SUBJECT: (6.1) 60 Kareela Road, Cremorne Point - Construction Traffic Management Plan - (Demolition Stage only)

AUTHOR: Report of Traffic & Transport Engineer, Iman Mohammadi

Council has received a “Traffic Impact Assessment” prepared by “PTC Consultants”, dated 7 January 2020 for the approved development at 60 Kareela Road, Cremorne Point (Development Consent 202/19).

Figure 24 – Proposed Temporary Parking Controls

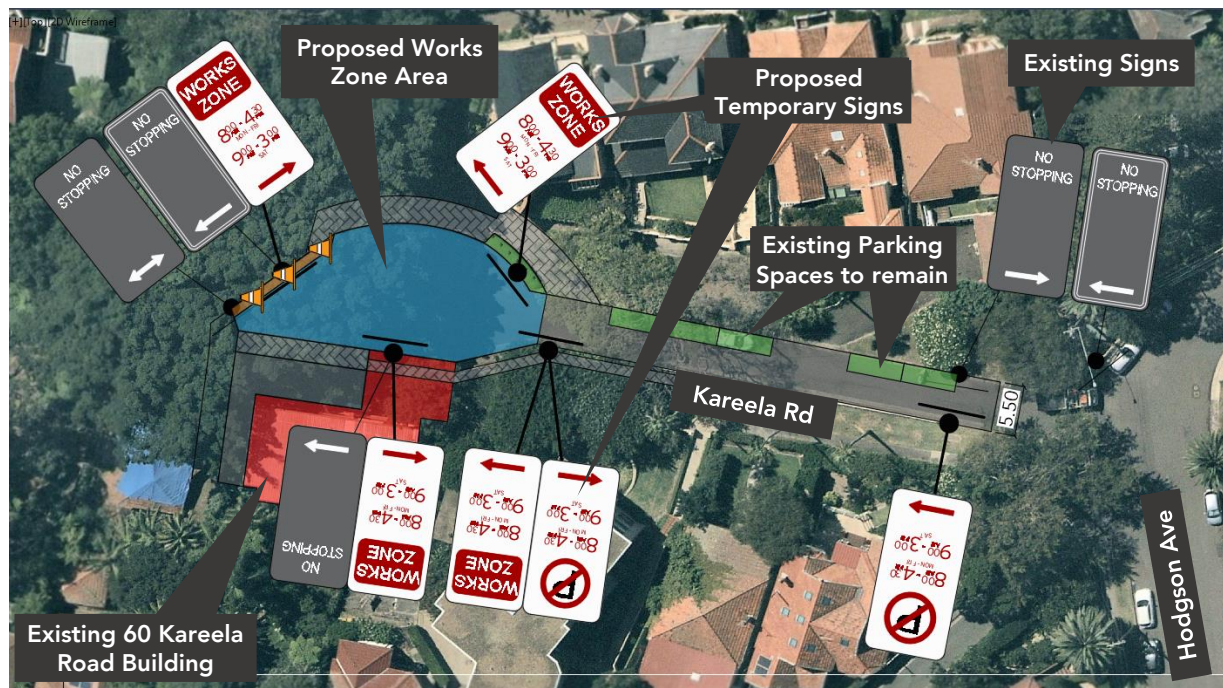
The “Work Zone 8am-4:30pm Mon-Fri and 9am-3pm Sat” signs on the eastern side of cul-de-sac (opposite the site) as shown on figure 24 “Proposed Temporary Parking Controls” on page 29 of the report shall be changed to “No Stopping 8am-4:30pm Mon-Fri and 9am-3pm Sat”

11. The "Work Zone 8am-4:30pm Mon-Fri and 9am-3pm Sat" signs on the eastern side of cul-de-sac (opposite the site) as shown on figure 24 "Proposed Temporary Parking Controls" on page 29 of the report shall be changed to "No Stopping 8am-4:30pm Mon-Fri and 9am-3pm Sat"
